Interactive comment on “Water yield following forest–grass–forest transitions” by Katherine J. Elliott et al.

Interactive comment on “Water yield following forest–grass–forest transitions” by Katherine J. Elliott et al. Anonymous Referee #1 Received and published: 23 November 2016

Interactive comment on Hydrol. Earth Syst. Sci. Discuss., doi:10.5194/hess-2016-548, 2016.

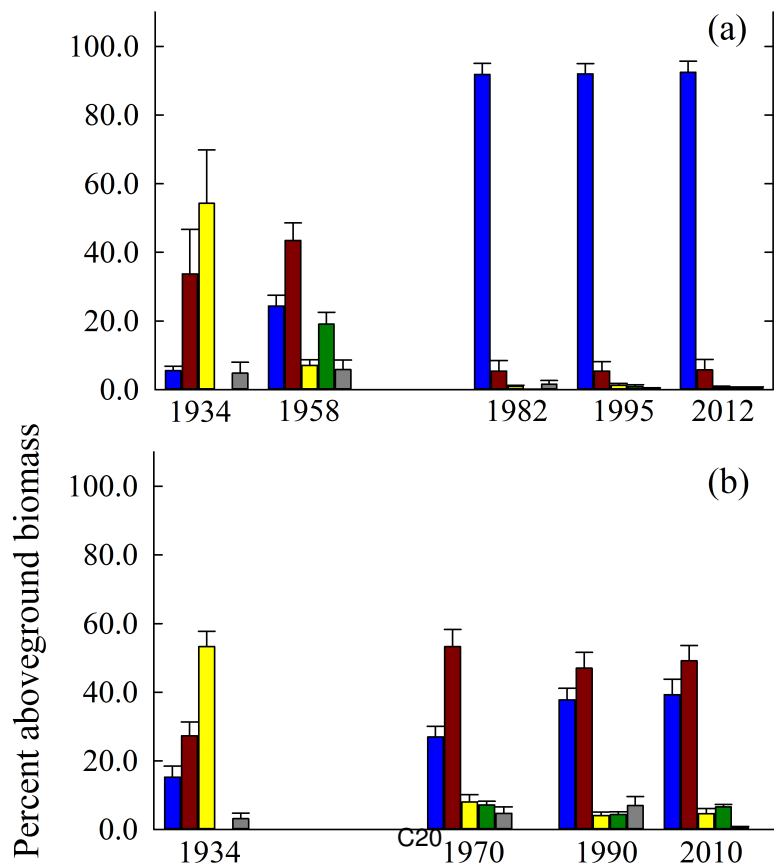
Figure 1: In the methods you mention estimating aboveground biomass but not leaf biomass – how was this estimated?

Response: now Figure 2, we also used allometric equation for leaf biomass, we added ‘leaf biomass’ to the sentences on lines 200-204, “Median DBH values were used to calculate basal area, aboveground biomass, leaf biomass, and LAI. We used species-specific allometric equations developed on-site to estimate the aboveground biomass, leaf biomass, and LAI contribution of each species in each watershed (McGinty, 1972; Santee and Monk, 1981; Martin et al., 1998; Ford and Vose, 2007; B.D. Kloeppel,

Fig. 4. Changes in water yield

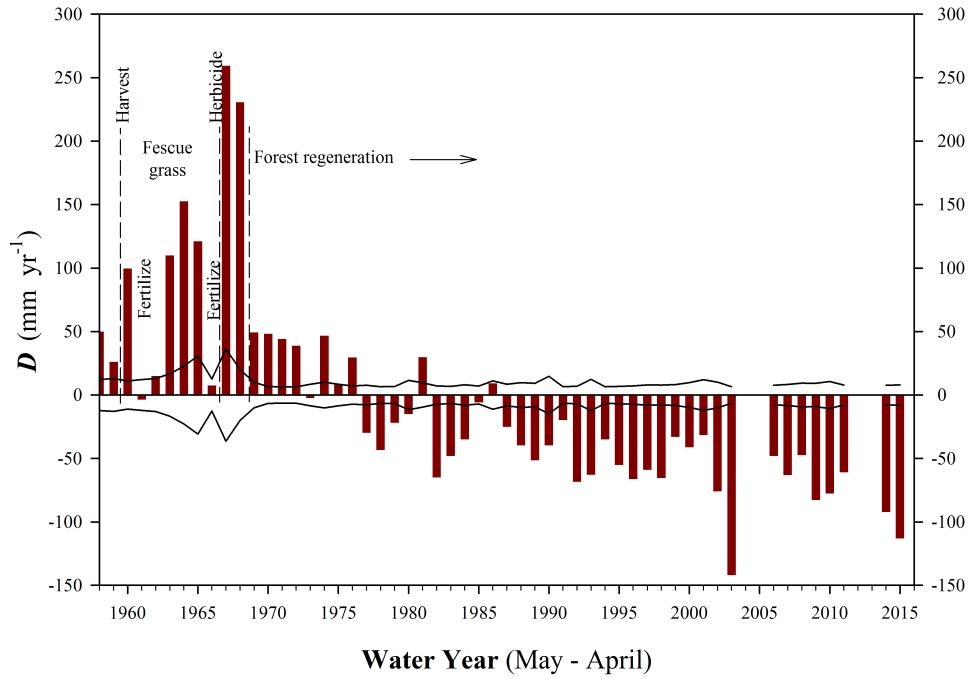
The authors report monthly deviations in Q, but I miss a thorough discussion about potential causes of some aspects of these results. There is a discussion about Q being lower than expected during wet months during the growing season, and I agree with the authors here, but why is there no effect during other months in the growing season (i.e. months that are not classified as wet). Should you not expect to see the same pattern in those months? And I found no convincing explanation to why Q is higher than expected during wet months during the dormant season. Also, according to figure 4b, Q is lower than expected at around average wetness during the dormant season. Why is that?

Response: We discuss why Q is higher than expected during wet months during the dormant season on lines 505-522, here we suggest that because WS6 after treatment does not have rhododendron or hemlock (evergreen species) ET would be lower than in the reference watershed where they remain a component. For example, “More likely the higher than expected Q in the dormant season is due to the lack of evergreen species in the treated watershed.” On lines 510-512.
